Docket Item #13-C  
DEVELOPMENT SPECIAL USE PERMIT #2002-0009  
1700 DUKE ST – MIXED USE DEVELOPMENT

Planning Commission Meeting  
September 3, 2002

**ISSUE:** Consideration of a request for a development special use permit, with site plan, for construction of a mixed-use building.

**LOCATION:** 1700 Duke Street

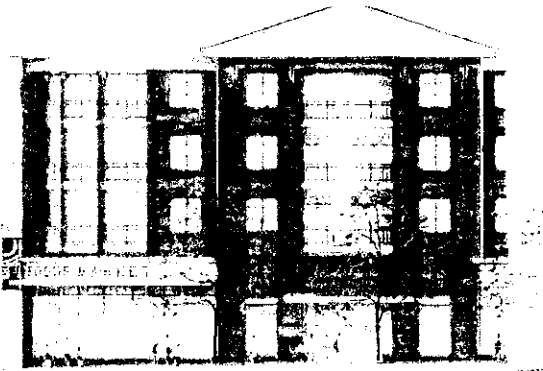
successfully accomplish this goal. To reduce the mass of the building staff has worked with the applicant to break the building into a series of vertical bays, with each bay providing additional vertical and horizontal articulation to further break up the mass of the building. Portions of the building have been set back 4' while other portions of the building are now projecting 6', providing significant offsets for the building facades. In addition to the significant level of building articulation, staff has included conditions of approval that will result in significantly more variation in materials, colors and textures while also providing a more prominent corner element for the building. The proposal by staff and the applicants proposal are depicted below

Applicants Proposal

Staff Proposal

**Figure 1**  
**Holland Lane**  
**Proposed Lane Configuration & Lane Widths**  
**Scale: 1"=60'**

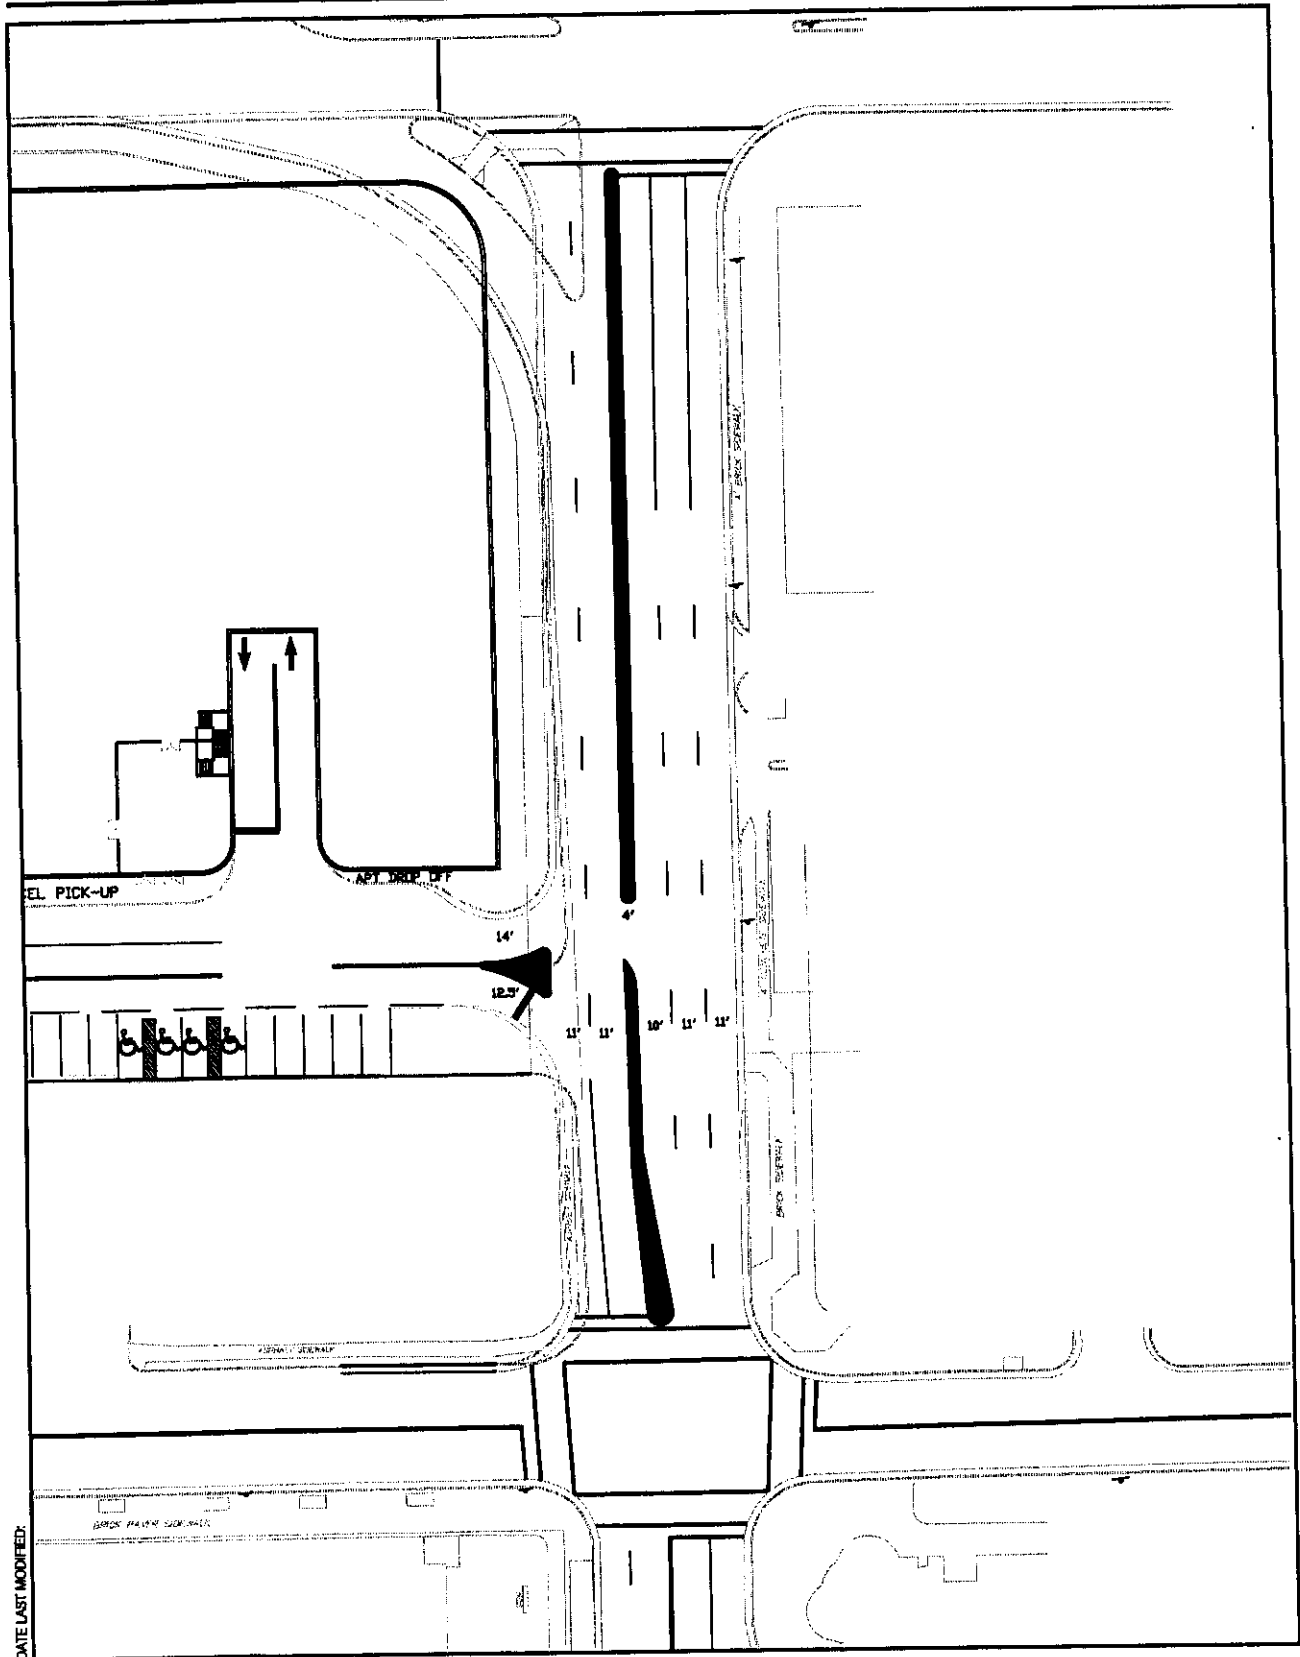
1. The proposed configuration of a northbound left-turn into the Whole Foods site along Holland Lane will be permitted during the off-peak hours of the day.
2. Based on the off peak traffic volumes in the year 2020, Holland Lane and Duke street would have, on average, minimal queuing.
3. No northbound left turns into the site will be permitted during the AM and PM Peak periods.
4. Signs will be installed to restrict northbound left turns into the site during the peak periods.
5. Gorove/Slade Associates preliminary Left-Turn Analyses Memorandum, dated February 27, 2002 is attached to this memorandum.
